Subject: Supplemental Information to WCAP-17524, "AP1000 Core Reference Report" to Address Thermal Conductivity Degradation (Proprietary/Non-Proprietary)

Subject: Westinghouse Response to NRC RAIs on WCAP-17524, "AP1000 Core Reference Report"
(Proprietary/Non-Proprietary).

**Westinghouse Response to NRC RAIs on WCAP-17524, “AP1000 Core Reference Report”
(Non-Proprietary)**

Figure 15.6.5.4A-9

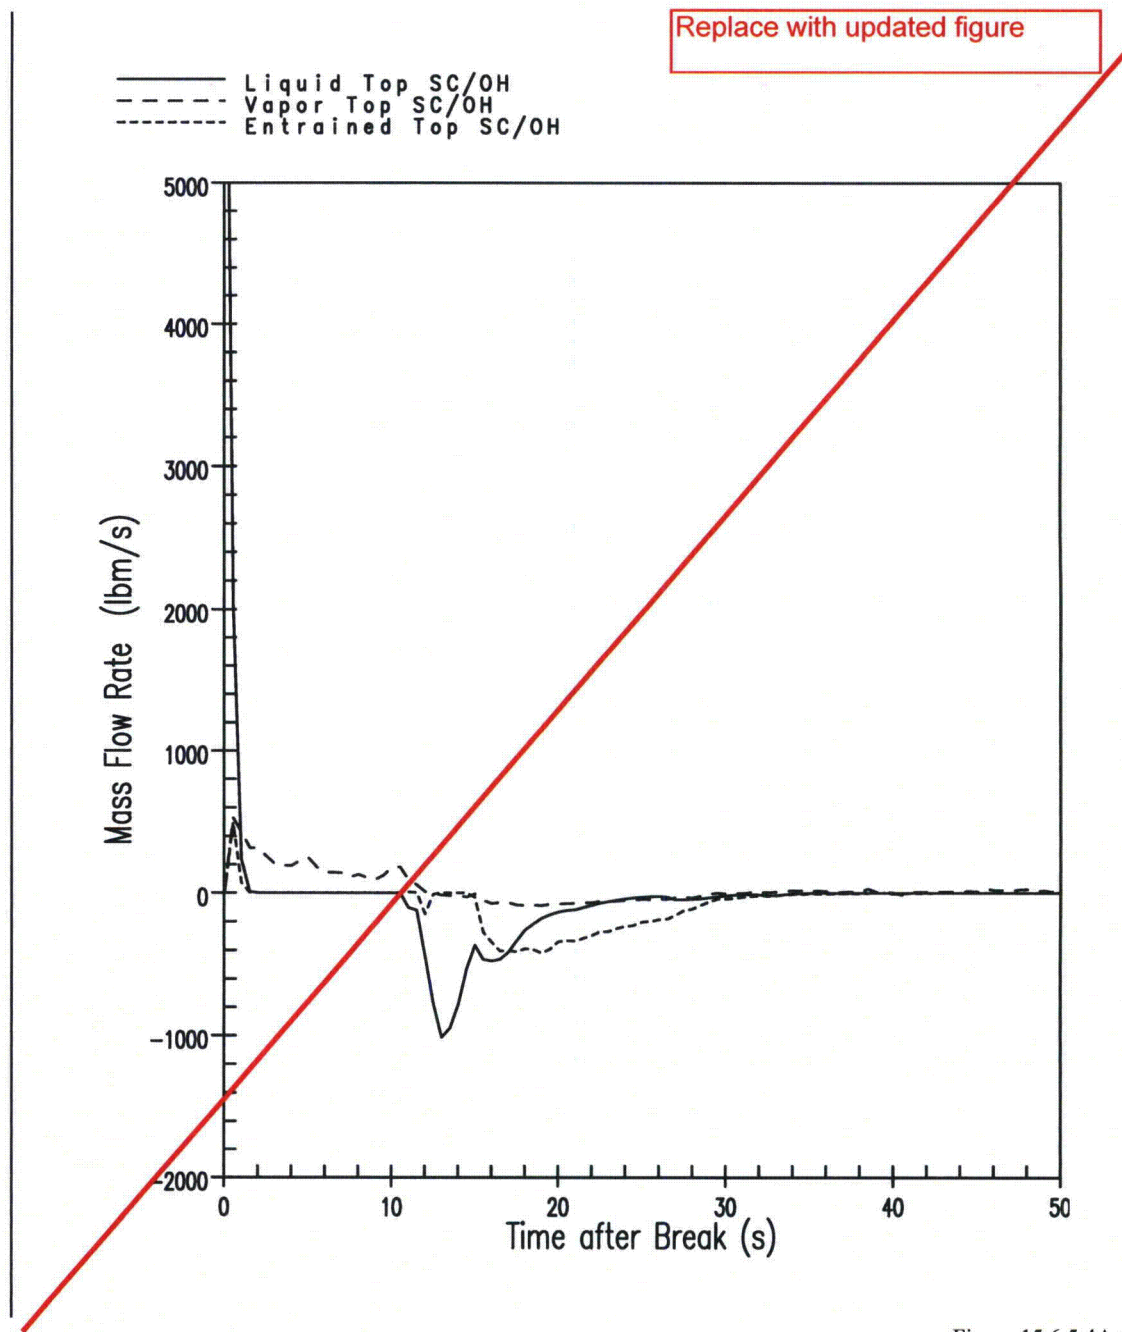
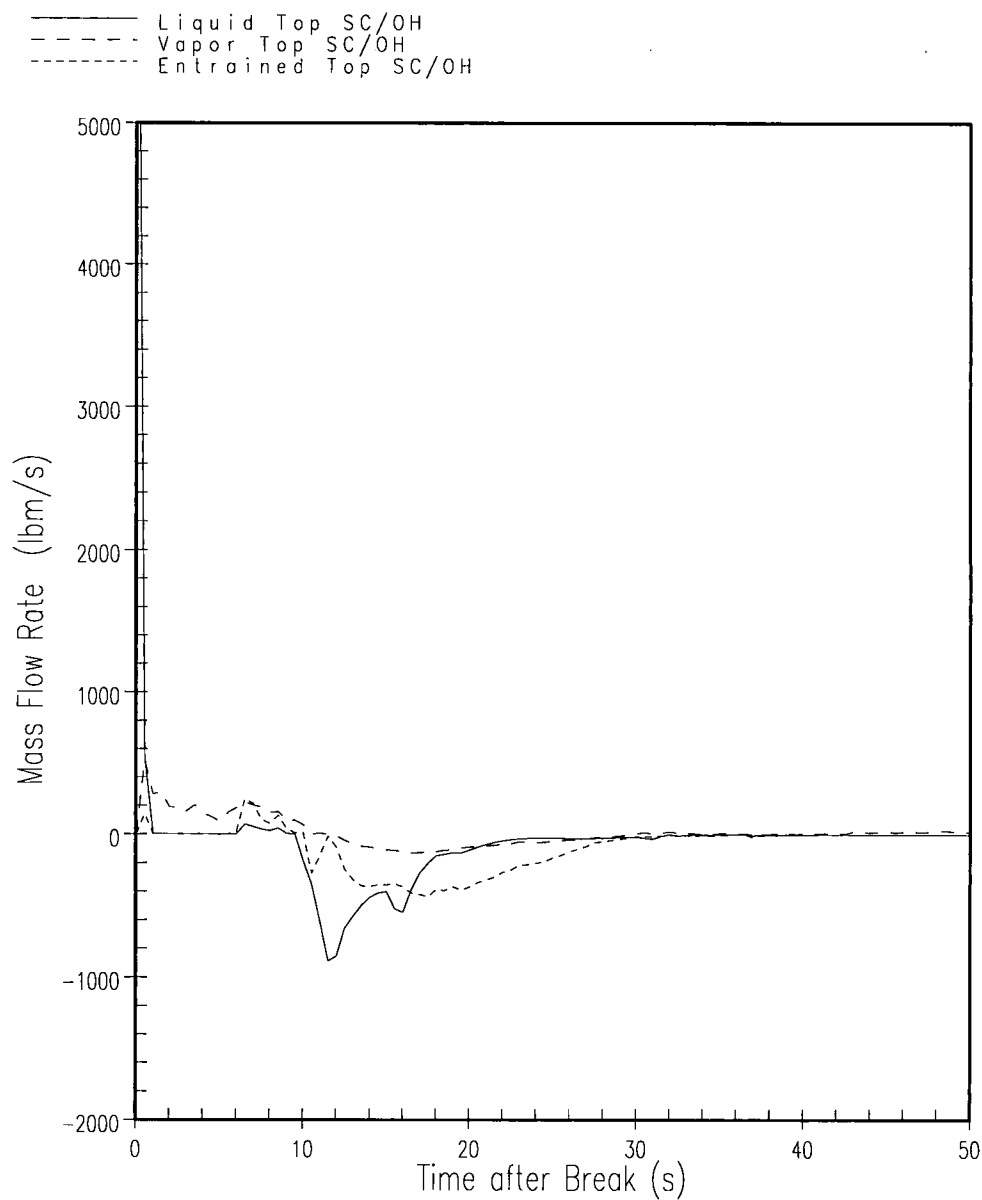
Figure 15.6.5.4A-9 presents the open hole/support column assembly top of core flow behavior. In this case, there is liquid downflow into the support column/open hole assemblies from 11 seconds until 22 seconds; the entrained liquid flow continues to be significant until 30 seconds as fluid drains through the upper core plate holes into the upper plenum. Figure 15.6.5.4A-8 shows that in the 95th percent estimator PCT/MLO case, the liquid downflow into the guide tube assemblies occurs from 14 seconds to 22 seconds; in this case the downflow is delayed relative to the liquid downflow in the support column/open hole assemblies due to the steam generation and resulting significant vapor upflow at the top of active fuel in the guide tube assemblies during blowdown.

Figure 15.6.5.4A-10

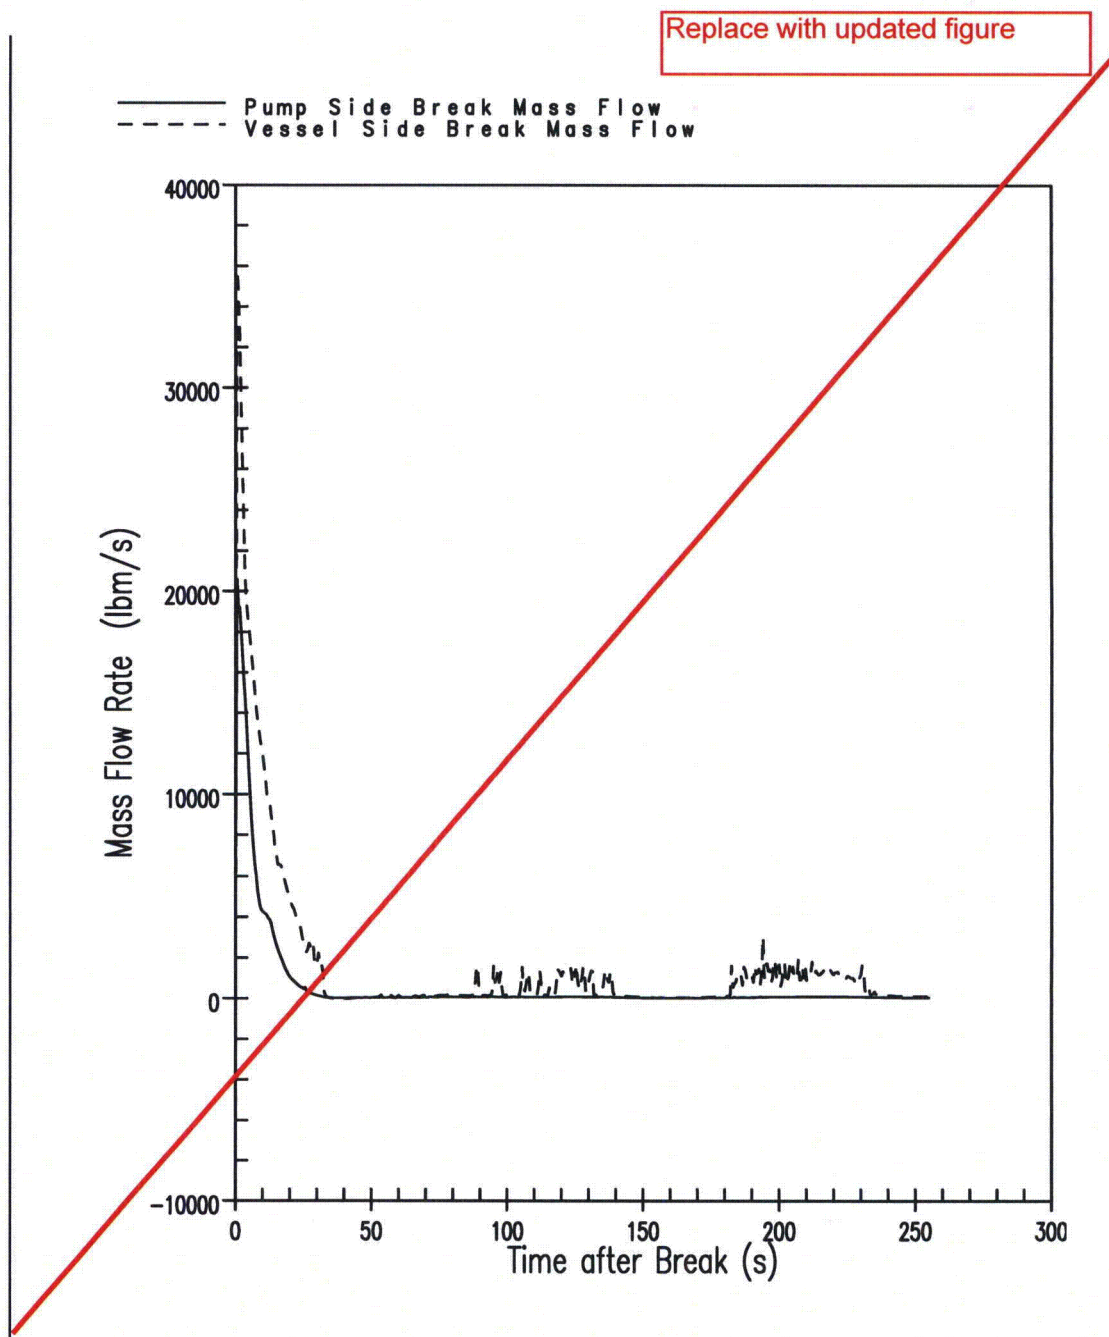
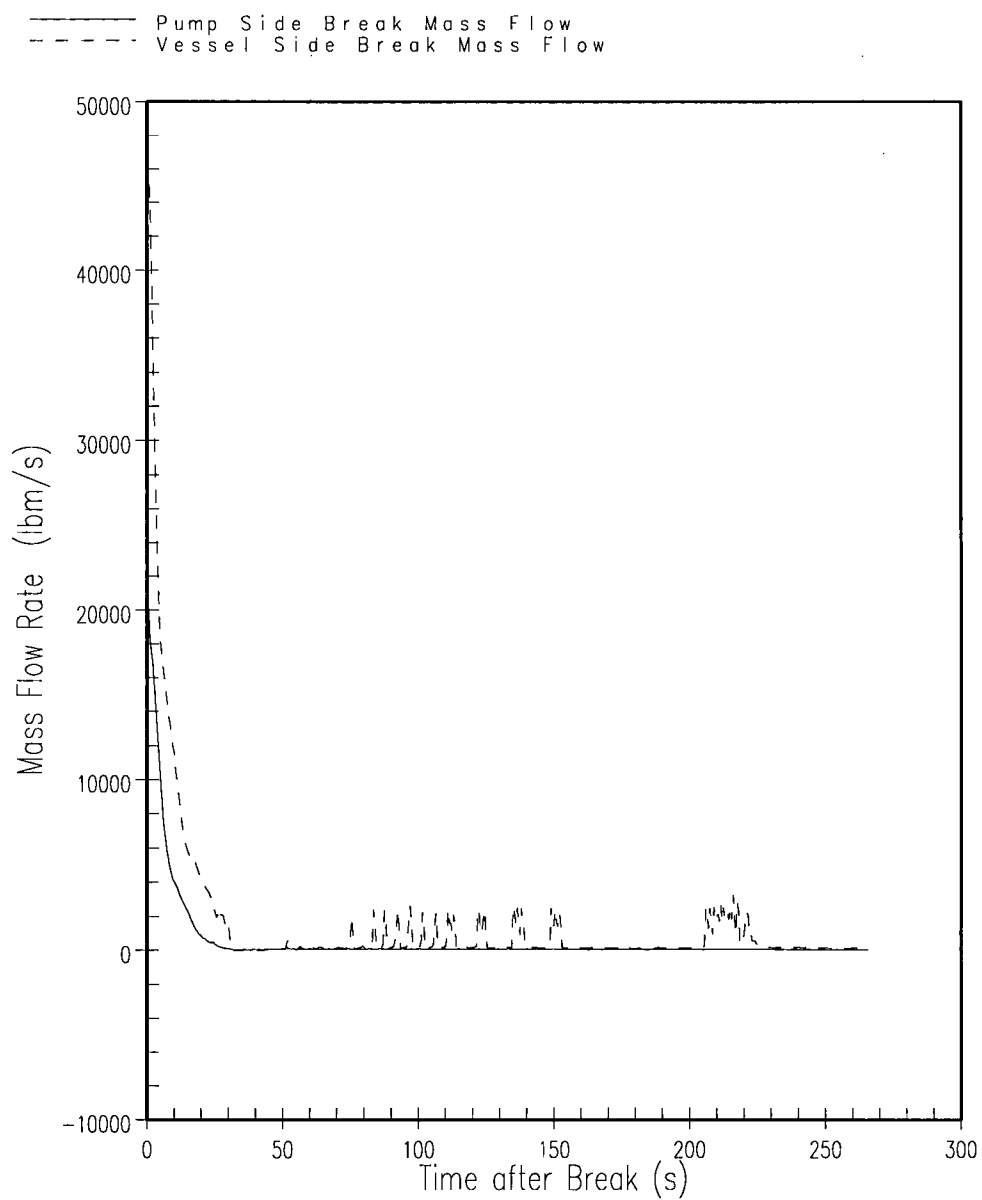
After 13 seconds into the transient, the accumulator begins to inject water into the upper downcomer region, most of which is initially bypassed to the break. The break flow rate diminishes as the transient progresses (Figure 15.6.5.4A-10). At 28.5 seconds, the accumulator injection begins to refill the lower plenum. At approximately 41.0 seconds, the lower plenum fills to the point that water begins to reflood the core from below (Figure 15.6.5.4A-11). The void fraction at the core bottom begins to decrease, and as time passes, core cooling increases substantially. Figure 15.6.5.4A-11 presents the collapsed liquid levels in the core; Figure 15.6.5.4A-12 presents the collapsed liquid levels in the downcomer. The cladding temperature begins to decrease once the core water level has risen high enough in the core.

Figure 1: Fuel Assembly Damping Factors in Air and Still Water – Westinghouse Test Data

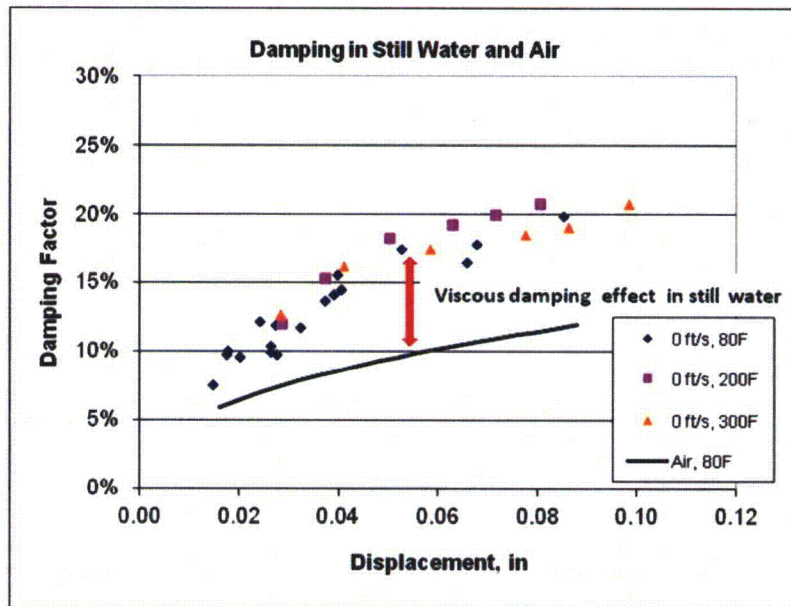
The Westinghouse test data provides a direct comparison of the damping values due to the different environments (air, still water, and flowing water) as shown in Figures 1 and 2. Furthermore, the data in Figure 2 and the data given in Reference 2 provide similar damping values. Other similarities between the data are (1) the damping values in air and still water are amplitude dependant and (2) the damping in flowing water is significantly higher than in air and still water and is less amplitude dependant. This comparison demonstrates that minor differences in design do not result in significant differences in damping. It should also be noted that the test assembly used in Reference 2 has a 17x17 array, 8 mid grids and 264 fuel rods with 0.374 inch OD. These parameters are the same as for the **AP1000** PWR fuel assembly.
